Environmental Review Team Report

# Pattaconk Hollow

Chester, Connecticut

March 1980

SITE PLAN  
CHESTER, CT.

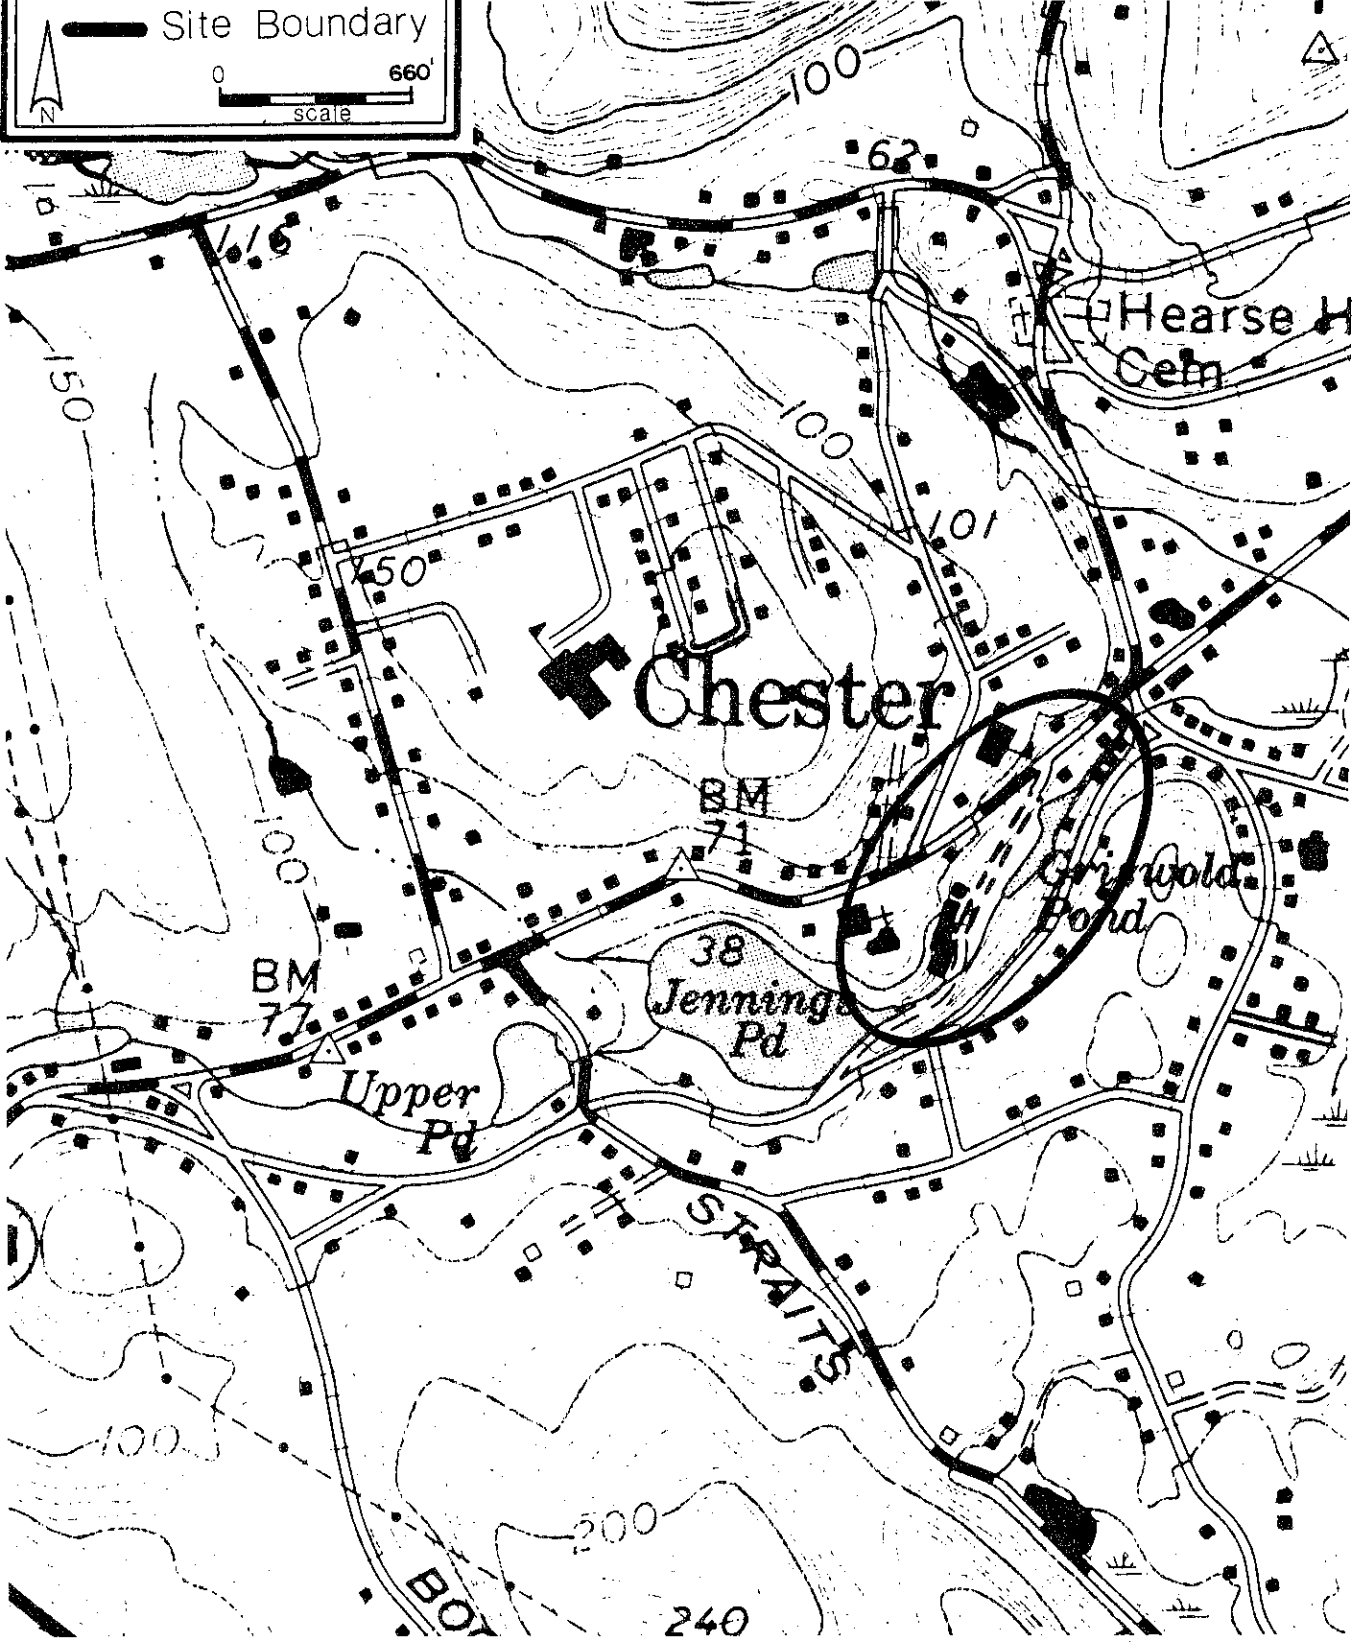
The storm drainage system which will be installed on the south side of the site will alleviate erosion problems on that steep slope; however, it may also be discharging road contaminants, such as sand and salt, directly into the brook.

Comparison of the flood elevations shown on the HUD map with the topography shown on the developer's December, 1979, blueprint indicates that most of the proposed dwelling locations lie outside of the 100-year flood zone. Exceptions are the existing barn on lot 7, the northern portion of the proposed house on lot 6, and the southern portion of the proposed house on lot 4. Proposed dwellings in lots 2 and 3 might also be affected during a 500-year flood. Although the developer's engineer has stipulated the developer's intention to keep all houses above the 100-year flood elevations, the team feels that such intentions should be manifested clearly on future site plans by showing the exact location of the HUD floodprone-area boundary and by keeping all houses outside of this boundary. For additional safety, the 500-year floodprone zone should also be designated in future plans.

The present blueprint incorporates a rerouting of part of the flow of Pattaconk Brook through a rechanneled section of the existing "tail race". The idea for this rerouting arose from the developer's desire to alleviate the stagnant situation now present in the race. In the area of the proposed diversion Pattaconk Brook's channel is straight. In order to induce the flow to bend in the manner desired, the bed of the new race would have to be lower than the bed of the existing channel. Alternatively, to induce such a flow some obstruction would have to be created in the present channel just east of the proposed intersection. If neither of these conditions were met, it is unlikely that any significant flow would pass through the new race. Indeed, natural processes would lead to sedimentation at the entrance to the race, with diverted flow becoming more and more restricted. On the other hand, if an effective diversion were created, the present channel of the brook may experience stagnation and/or sedimentation. Hence, the ultimate advantage of the proposed rechanneling is unclear.

The developer has proposed some rechanneling of storm drainage from Spring Street in the area of lots 5, 6, and 7. The present system has five outlets onto the site, with discharges running along the surface either until reaching the brook or until being absorbed into the ground. The proposed system would route these discharges through three pipes, with outlet points (in rip-rap) immediately adjacent to the brook. The new system would have the advantage of ameliorating the existing erosion problems on the steep slope north of Spring Street. It would have the disadvantage of directly discharging road-derived contaminants (such as sand and salt) into the brook.

One of the most important hydrologic questions with regard to the proposed subdivision is the advisability of placing leaching fields for septic systems directly upslope from house sites. This situation exists in the current plans for lots 2 and 7. Apparently, at least in lot 7, household wastewater would have to be pumped uphill to be discharged through the septic system. Normal groundwater flow would carry the leachate back in the direction of the houses. In lot 2, it is difficult to see where a well could be placed in a position that would not be in the direct path of the returning effluent. The potential for well contamination would be high on this lot with the presently proposed set-up. In lot 7, the suggested well location is also within the possible zone of influence from septic effluent. Moreover, high groundwater levels observed in test pits on that lot raise concerns for potential effluent surfacing near, or leakage into, the basement of the proposed dwelling. A redesign of house and septic system locations on both lots 2 and 7 seems warranted. In making this suggestion, the Team

The three wells, with the exception of the one for proposed lot #7, are located towards the high side of the lots and would meet the minimum required separating distance from the proposed sewage disposal areas. A well for lot #7 should be better positioned, keeping towards a higher elevation, further separated from the proposed sewage disposal area and from the proposed storm drain line. Houses on Spring Street, opposite the proposed lots, should also be checked as to the location of their sewage disposal systems. If such systems are located towards the front yards, they could infringe on the necessary separating distance(s) from proposed well sites.
